SAFETY EVALUATION BY THE OFFICE OF NUCLEAR REACTOR REGULATION

SUPPORTING AMENDMENT NO. 77

YANKEE NUCLEAR POWER STATION (YANKEE)

Date: December 3, 1982

FIGURE 13.1

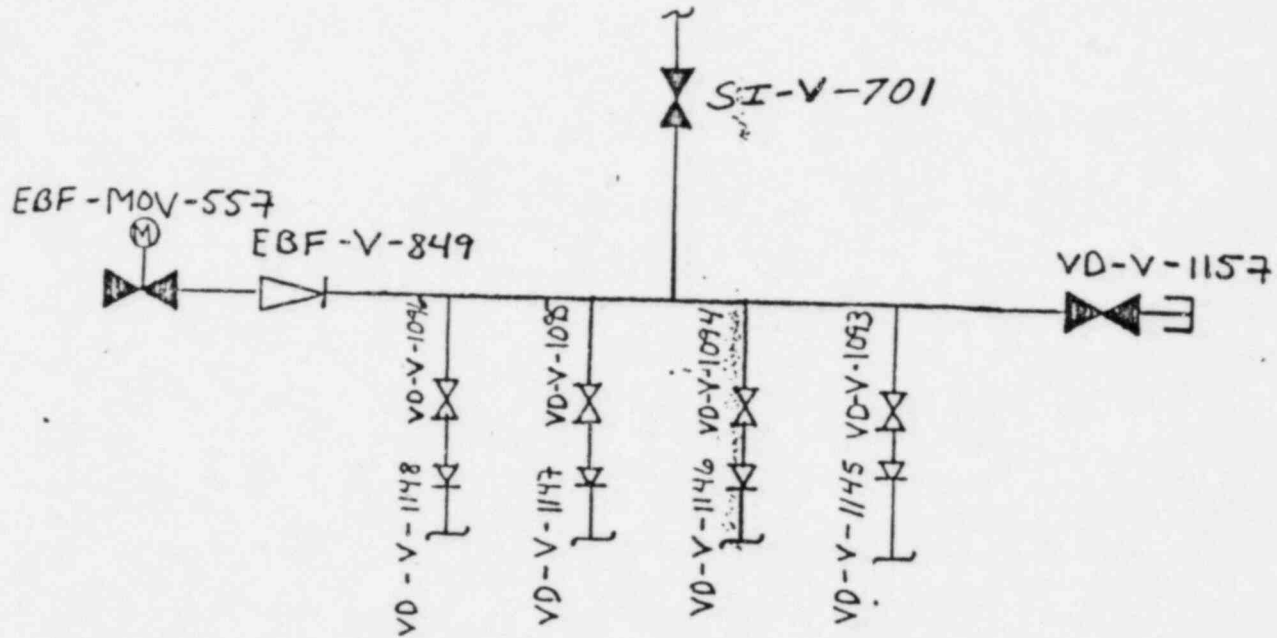
As a result of the Systematic Evaluation Program (SEP) seismic review, a new Hot Shutdown System has been proposed. During this refueling outage, pipe taps were installed to permit possible system installation during normal plant operation. Specifically the capped end of the alternate emergency feed header was removed and a normally closed 2-inch manual globe isolation valve, VD-V-1157, was installed and capped (see SK-82-19-2A).

As a result of this change, it was necessary to add containment valve VD-V-1157 to Table 3.6-1 of the Technical Specifications (TS). Valve SI-V-701 was also added to reflect the new boundary and valves VD-V-1093, 1094, 1095, and 1096 were deleted from the list. Because these valves are connected to the secondary side of the steam generators and are neither part of the reactor coolant pressure boundary nor connected directly to the containment atmosphere, their use in this way meets the requirements of General Design Criterion (GDC) 57 of Appendix A to 10 CFR 50. We therefore conclude that this TS change is acceptable.

FIGURE 13.2

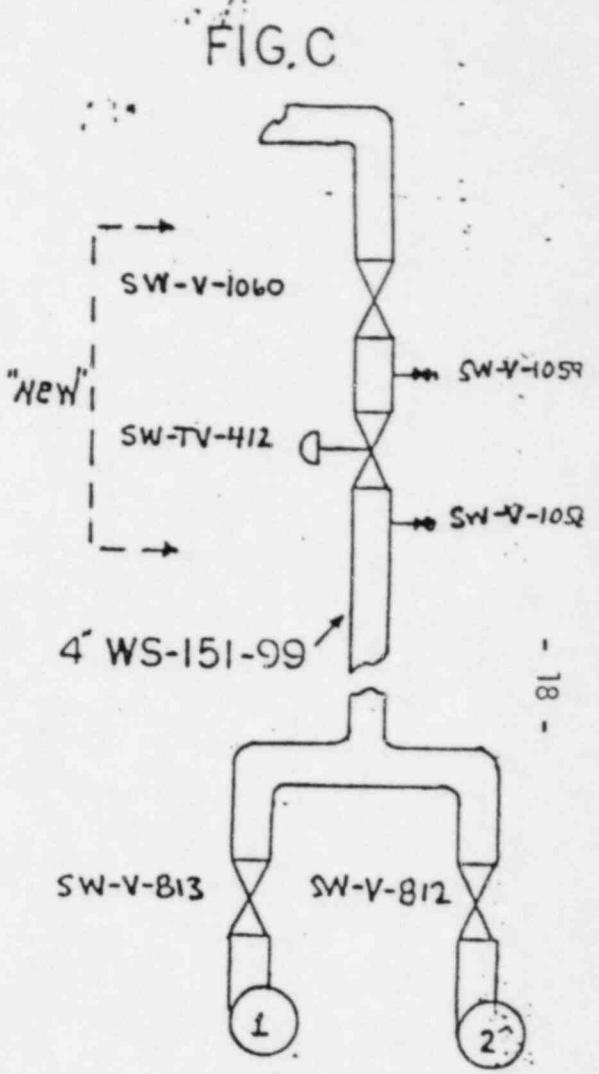
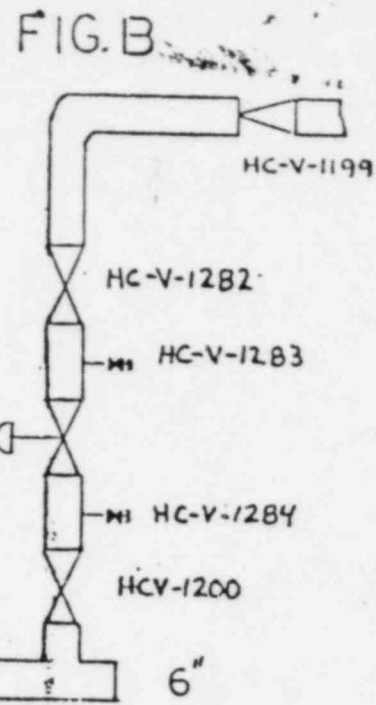
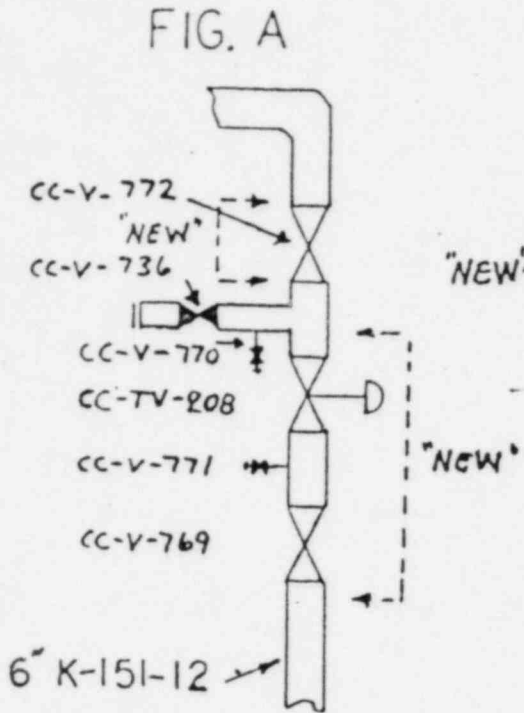
On September 2, 1982 the staff issued its evaluation of Yankee's request for exemption from certain provisions of Appendix J to 10 CFR 50 for certain valves. Based on that evaluation, the licensee installed new trip valves, block valves, and test valves in the Component Cooling Water Supply, the Service Water Supply, and Vapor Container (VC) Heat Steam Supply lines. These valves will be testable in accordance with Appendix J requirements and will replace previously installed check valves which were not testable. Sketch 82-9-51 contains Figures A, B, and C, respectively, which illustrate the changes which were made.

Figure A is the Component Cooling Supply Line. CC-V-772 and CC-V-769 will be normally open. These block valves will be used for the testing of CC-TV-208. CC-V-770 and CC-V-771 are test valves that are normally closed.

Figure B is the VC Heat Steam Supply Line. HC-V-1200 is existing and will be closed, along with HC-V-1282 as block valves, during the testing of HC-RV-413. HC-V-1283 and HC-V-1284 are test valves and are normally closed.

Figure C is the Service Water Supply Line. Valves SW-V-812 and SW-V-813 are existing and will be closed with SW-V-1060 and used as block valves for testing of SW-TV-412. Valves SW-V-1058 and SW-V-1059 are test taps.

Three new air-operated valves have been added to the Containment Isolation System (CIS). One of the valves, CC-TV-208, has been designated "essential;" the other two valves, SW-TV-412 and HC-TV-413, are "non-essential." "Essential" is defined as being required to be open during safety injection. All three valves have been incorporated into CIS in the same manner as the other CIS valves. Instrument air is provided from an air header in the upper PAB to each valve. Two solenoid valves have been placed in each line. One solenoid will energize on CIS "A" actuation; the other solenoid will energize on CIS "B" actuation. Energizing either solenoid valve vents air from the Air-Operated Valve (AOV) and the AOV closes. In addition to closing on CIS actuation, the "non-essential" valves will also close upon Safety Injection Actuation System (SIAS).

These modifications require the addition of valves TV-208, TV-412, and TV-413 to Table 3.6-1.

GDC 57 requires that "Each line that penetrates primary reactor containment and is neither part of the reactor coolant pressure boundary nor connected directly to the atmosphere shall have at least one containment isolation valve which shall be either automatic, or locked closed, or capable of remote manual operation." The Component Cooling Water lines, the VC Heat Steam Supply lines, and the Service Water lines are all part of systems which are closed inside the containment. The new valves will shut automatically on a containment isolation signal. The existing Component Cooling return line, the VC Heating Condensate return line, and the Service Water return line have existing automatic valves (TV-205, TV-409, and TV-408, respectively). We therefore conclude that the use of these valves in this fashion meets the requirements of GDC 57, and the changes to the TS are acceptable.
